MFN 15-053

GEH Responses to RAIs 19-6 through 19-9

ABWR DCD DRAFT Revision 6 Markups

FIGURE 3H.1-23 REACTOR BUILDING REACTOR CAVITY SHIELD BLOCKS
ABWR DCD REV 6 25A5675BB

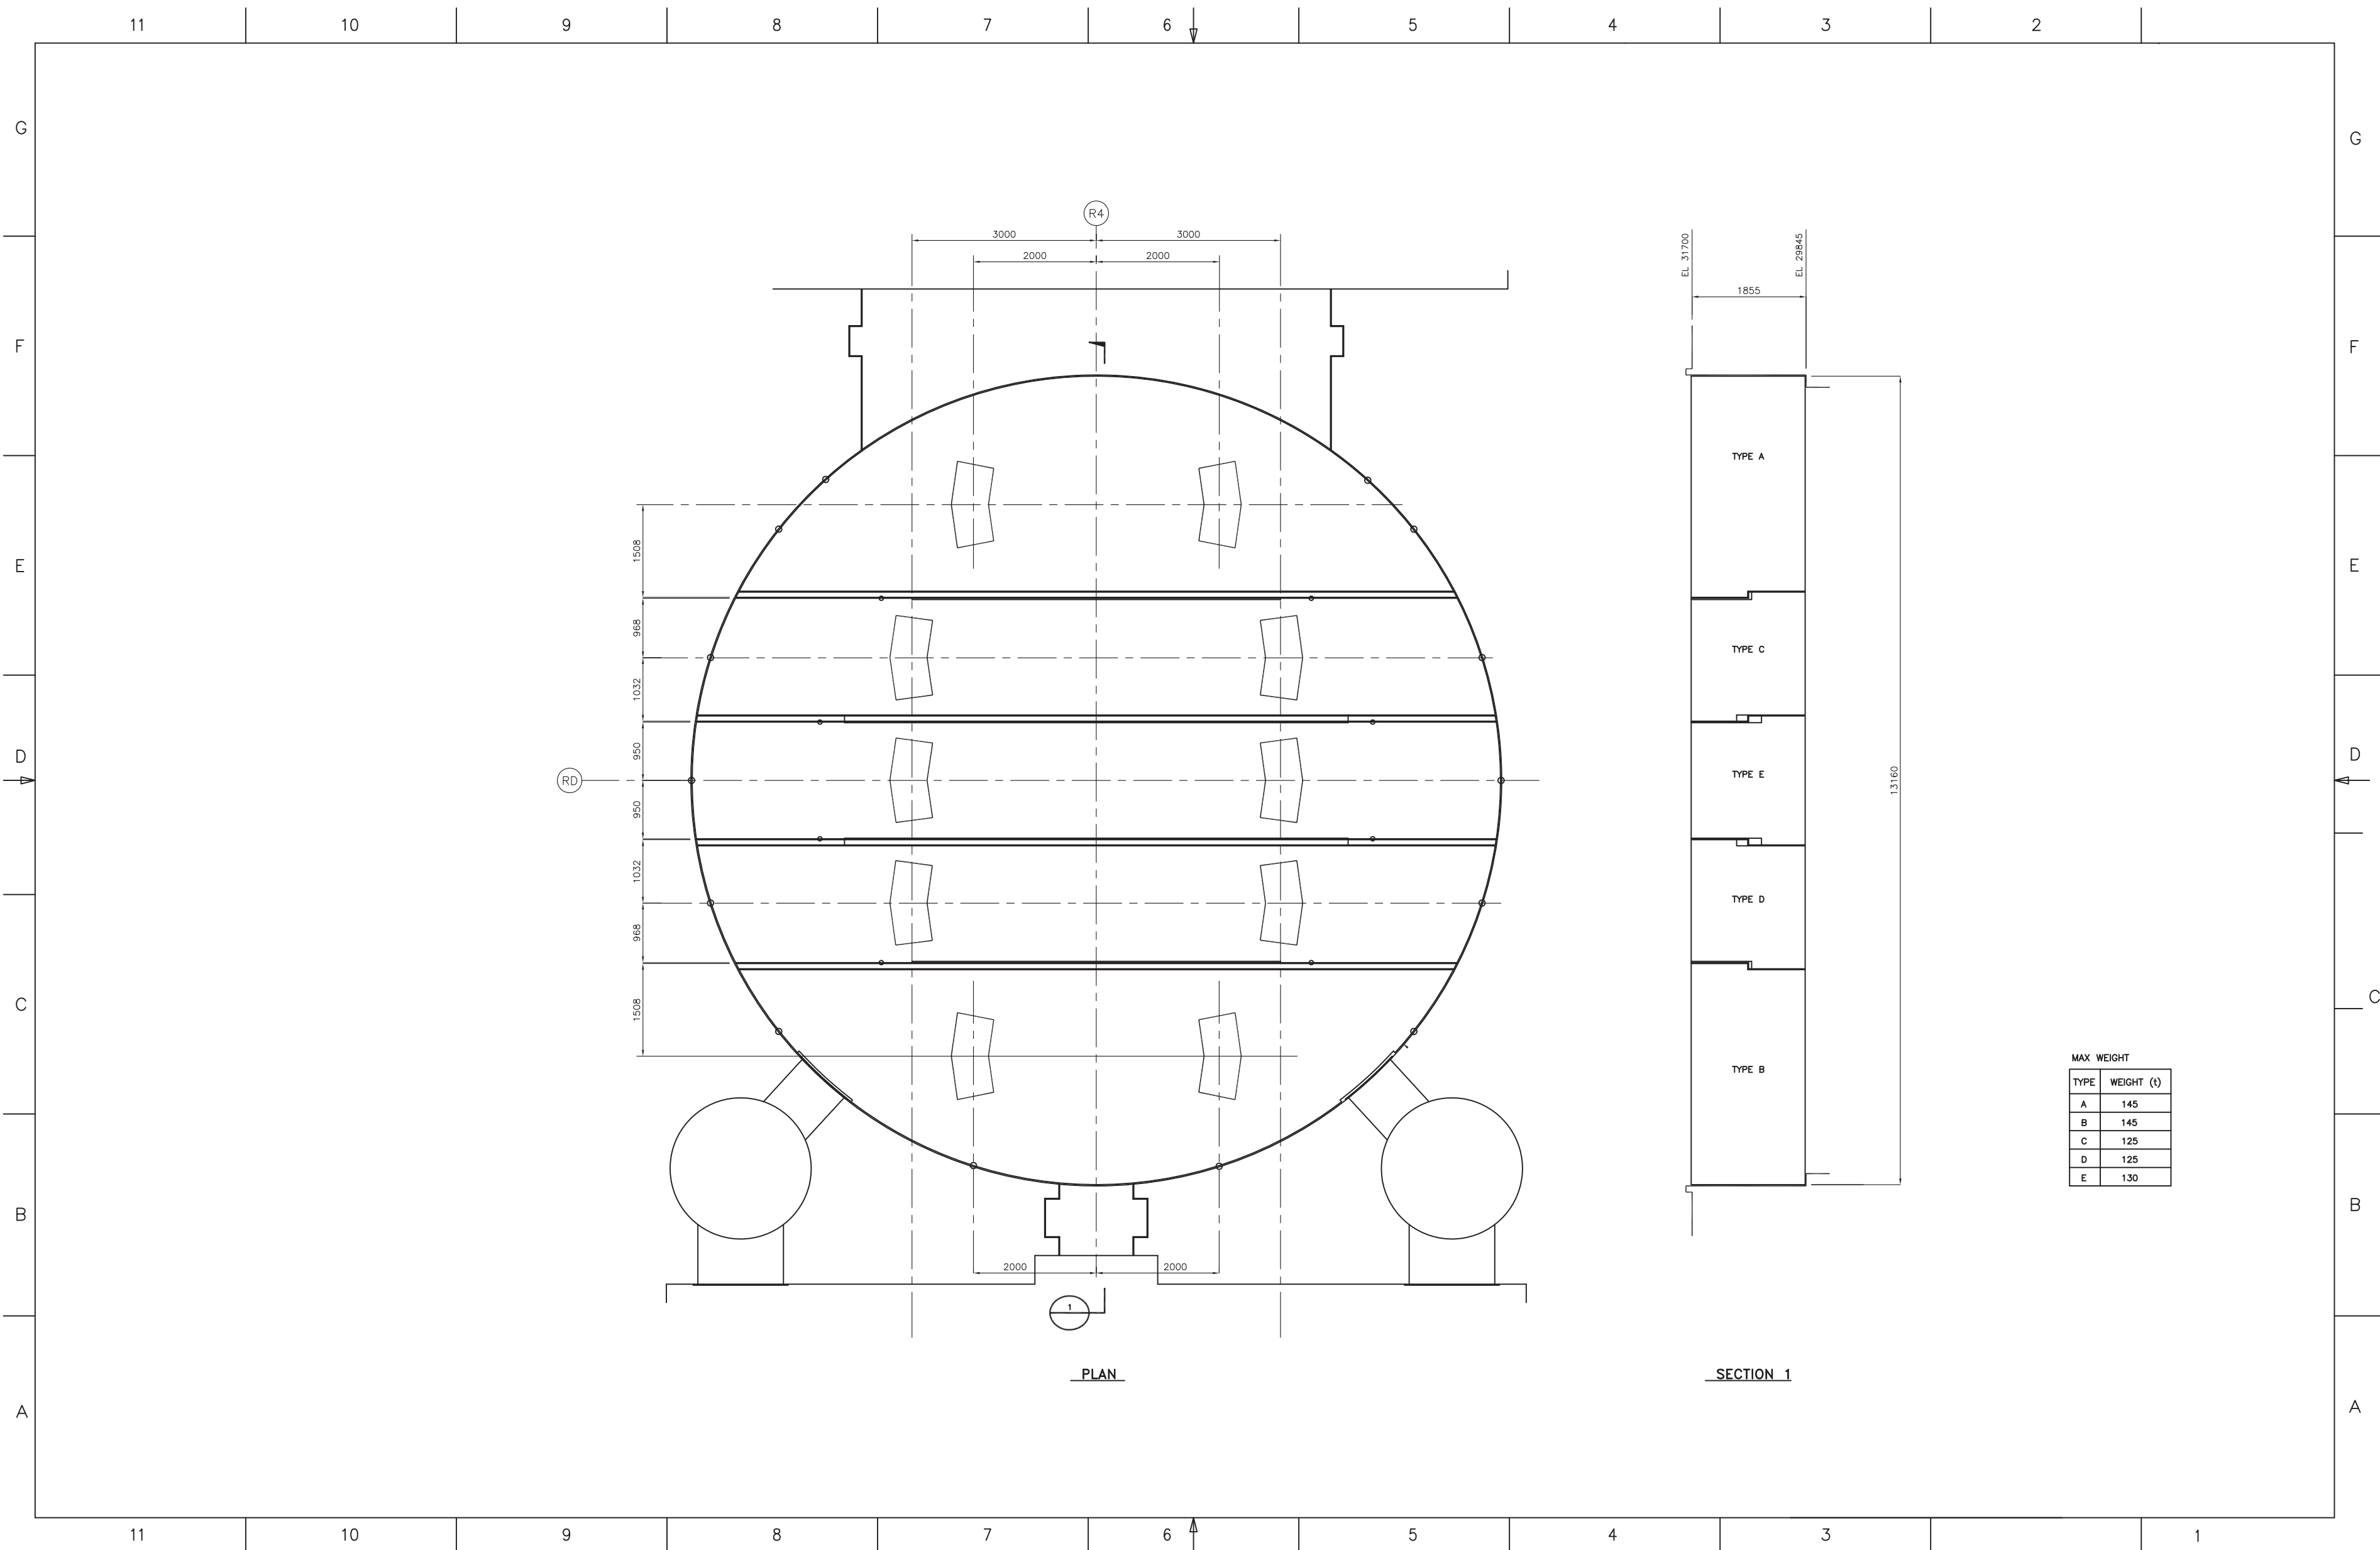
Reactor Cavity Shield Blocks as shown in Figure 3H.1-23 sit above the drywell head in the reactor cavity between the fuel pool girders. They provide missile shielding for the drywell head, and radiation shielding for maintenance personal on the operating floor during normal plant operations.

- (3) Shield blocks over drywell head ~~to be~~ **are** designed to fully resist secondary impact from concrete debris, aircraft wreckage, and falling crane components to protect integrity of drywell head.

- (4) ~~Exterior~~ **Interior partition** walls on 1F (Figure 1.2-8) and 2F (Figure 1.2-9) will be thickened to ~~1200mm~~ and strengthened with additional reinforcement to limit physical damage to ~~exterior wall~~ **The reactor cavity shield blocks are shown in Figure 3H.1-23.** **interior partition walls.**
